Docket Item #5  
BAR CASE # 2006-0280

BAR Meeting  
March 7, 2007

**ISSUE:** Addition and alterations  
**APPLICANT:** Andrew Macdonald by Cathleen Curtin  
**LOCATION:** 217 North Columbus Street  
**ZONE:** RM/Residential

Figure 3 - Proposed south elevation

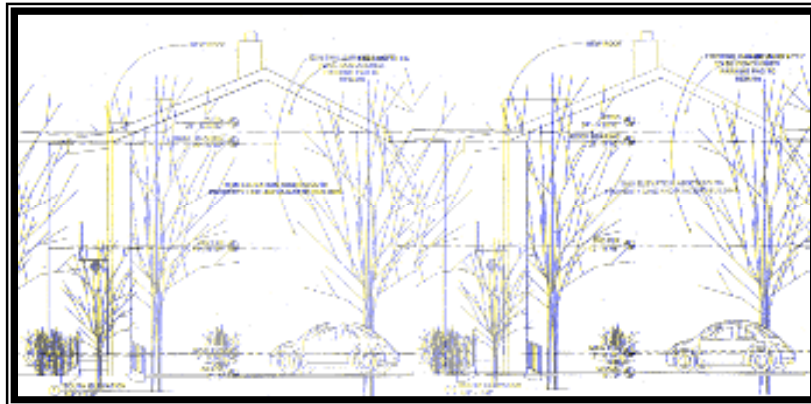
Staff is however concerned that the final details have not been selected or are inconsistent with the submitted drawings. For example, the applicant has not shown the location of the rooftop HVAC unit and design of its screening, and the location of a proposed Solatube. The applicant has also not shown the location and design of a Code required light fixture at the rear door and the proposed guttering system. Staff believes that additional information and clarification is needed including specifications of all materials prior to approval of the addition.
